**REVIEW AND CRITIQUE OF
PREVIOUS PROBABILISTIC ACCIDENT ASSESSMENTS FOR
THE SHOREHAM NUCLEAR POWER STATION**

**Report on Task 1 of the Project
"Consequence Assessment for Suffolk County Radiological Emergency Response Plan"**

**Prepared for
Radiological Emergency Response Plan
Steering Committee
Frank Jones, Chairman
Office of the County Executive
County of Suffolk
H. Lee Dennison Building
Hauppauge, New York 11788**

September 17, 1982

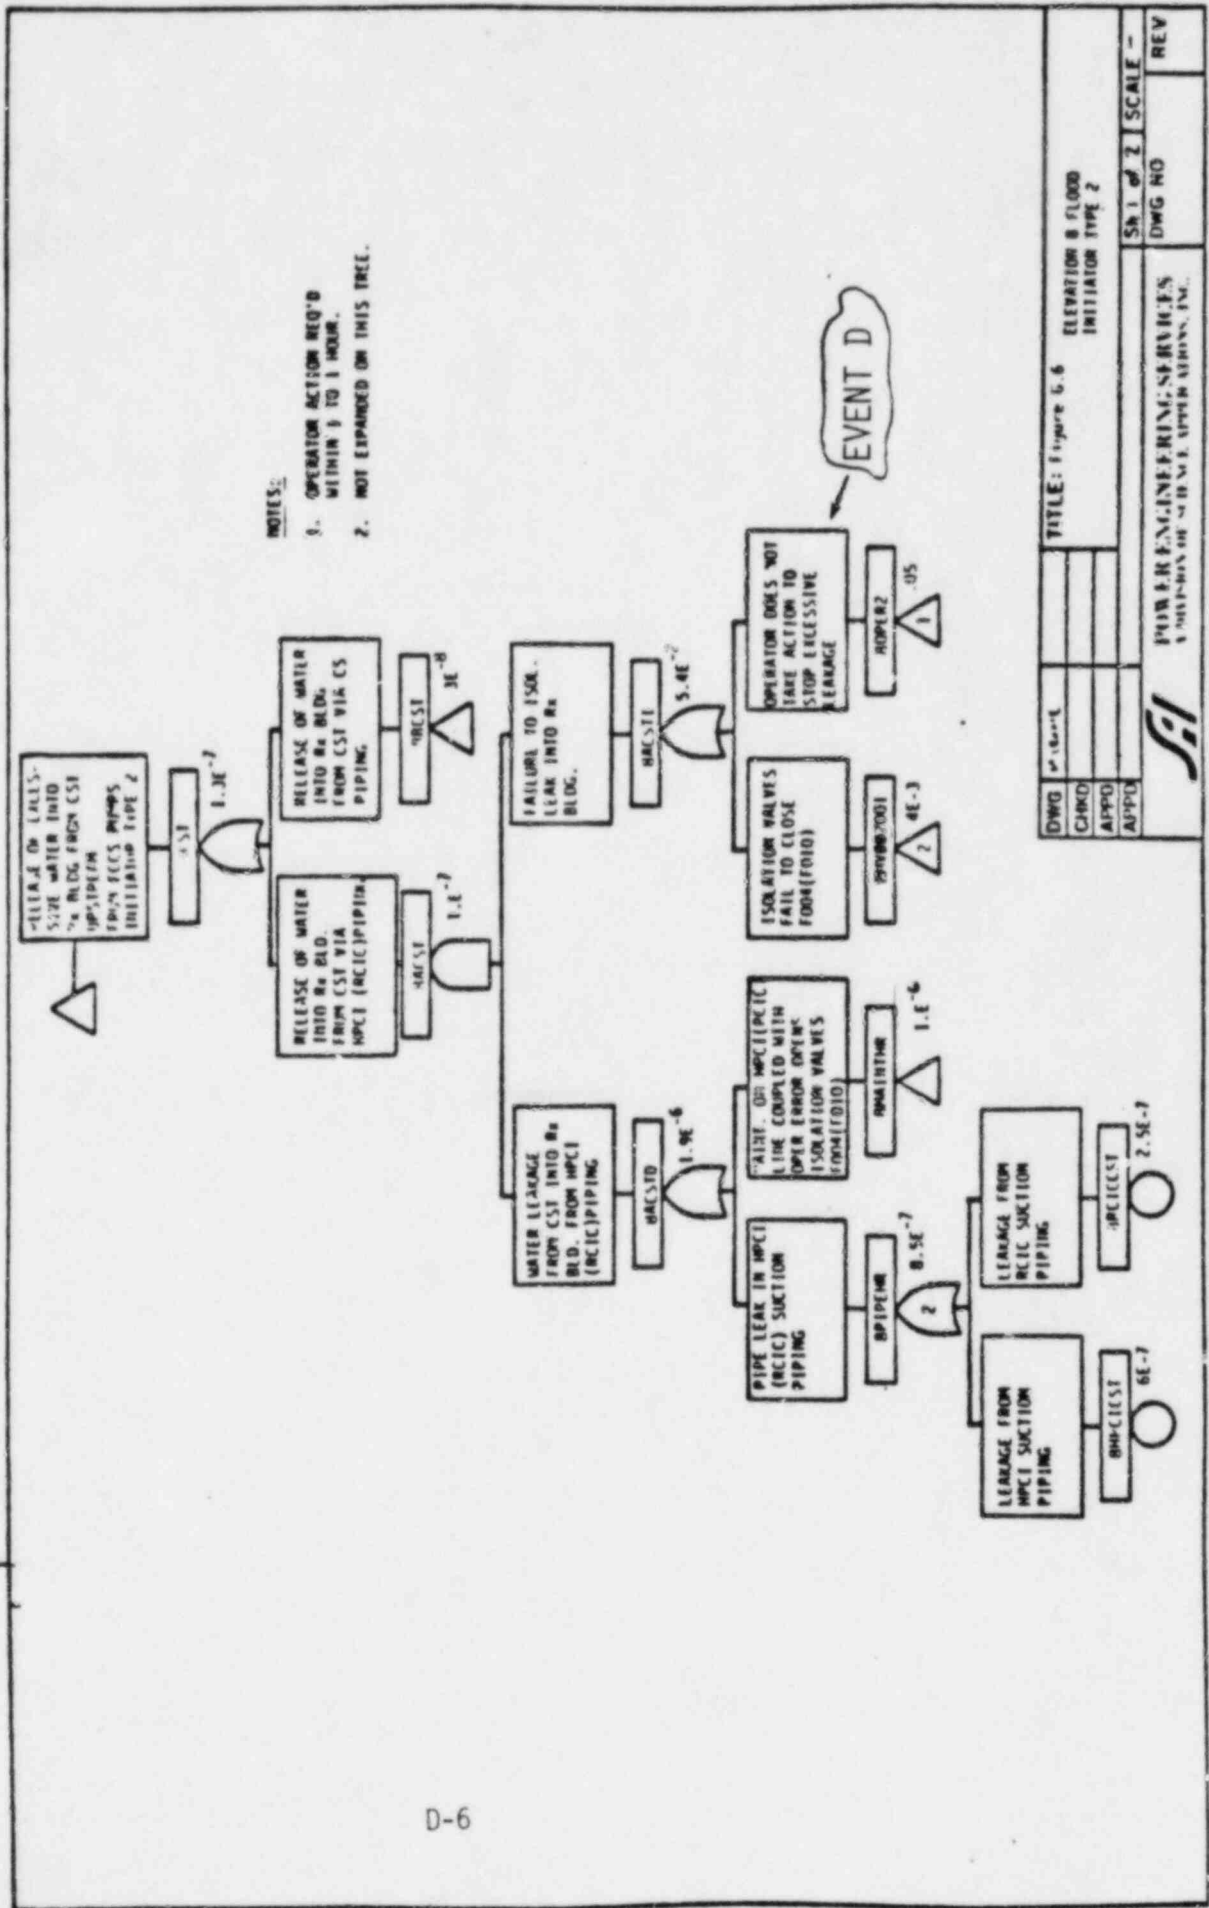
In this case, it should be noted that internal flooding does not result in loss of the power conversion system, a high pressure injection system normally on-line when the reactor is producing power. While flooding occurs, if the operator erroneously isolates the power conversion system (contrary to normal operating procedures), then an accident sequence is initiated as described by the bold line on the event tree in figure 3.4.23.

A typical fault tree development for the sequence described above is shown in figure G.6. It must be noted that SAI combined events A and B on the fault tree.

Figure 17-2. Estimated Human Performance after a Large LOCA

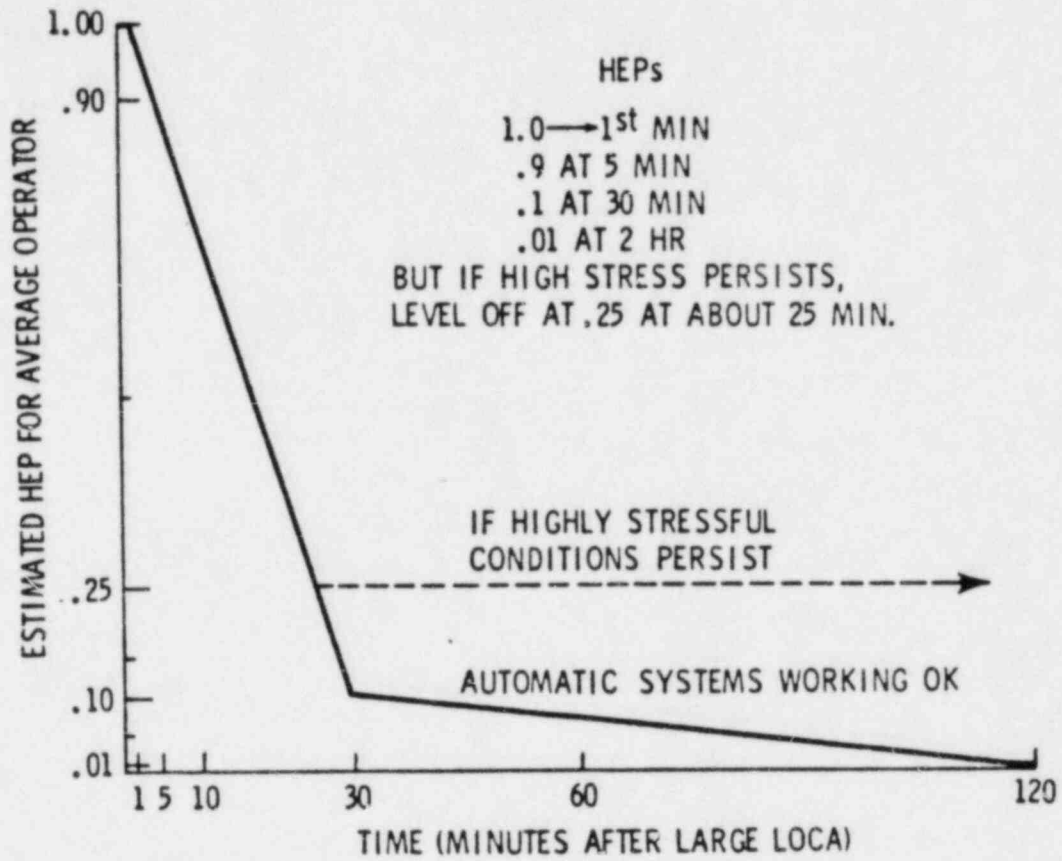
In addition SAI's estimate of the probability of failing to recover, $P(D/A \cap B \cap C)$, is 0.05 which corresponds to the non-stressful situation in figure 17-2, Swain and Guttman. However, if stressful conditions exist, then the estimate is a factor of 5 higher, i.e. 0.25.

Also, one can see from the event tree in figure 3.4.23, that SAI assigned a probability of 0.12 to failing to restore the condensate system. Considering the level of stress involved, a probability of 0.25 or higher could be a more reasonable estimate.

Figure G.17 Time Dependent Operator Error Rate
Applicable to the Operator Response
for Internal Flooding in the Elevation 8
Compartment.

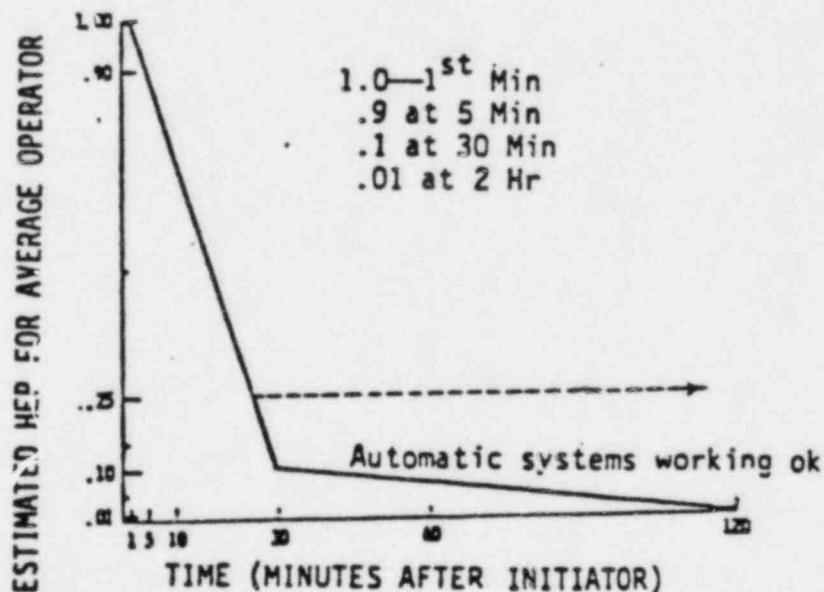
In addition to these input quantities, there is another vital aspect of the quantification, the time dependent operator intervention error rate. Figure G.17 displays the error rate used to characterize the control room operator response to a rising water level in the sump tanks and subsequently in the Elevation 8 compartment.
